ATOMIC POWER COMPANY •

August 22, 1985
MN-85-153

Subject: Maine Yankee Control Room Design Review

Per your request, attached please find the HED resolution package. This package was previously sent to you informally on August 8, 1985.

SKETCH # 4, EDCR # 85-12

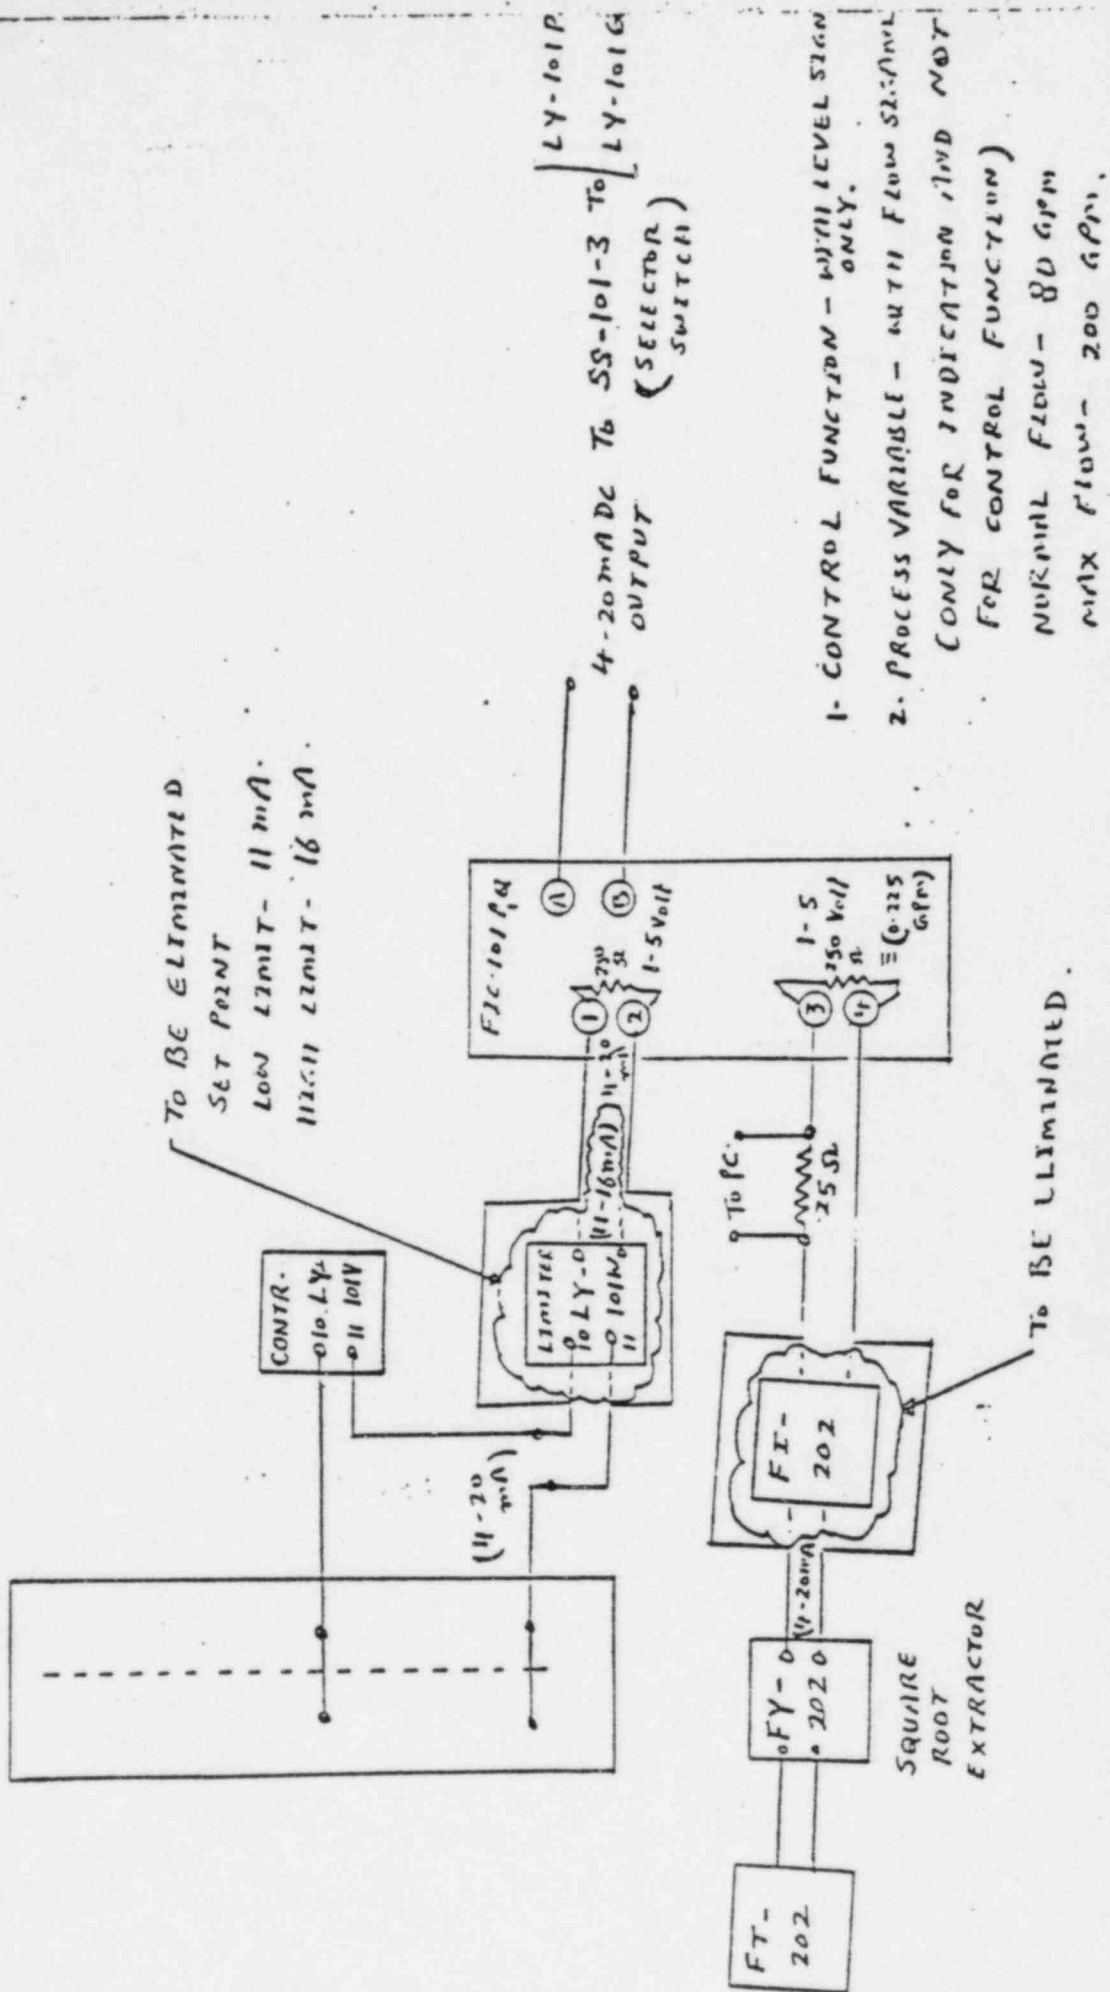
1. THE PROCESS VARIABLE POINTER COLOR WILL BE CHANGED FROM "RED TO BLACK" BY I/C DEPT. DUE TO H-F. REQUIREMENTS.
2. MANUAL OPERATION LEVER SLOT WIDTH WILL BE REDUCED BY I/C DEPT TO AVOID THE POSSIBILITY OF OVERTHROWING OF THE PROCESS VARIABLE.
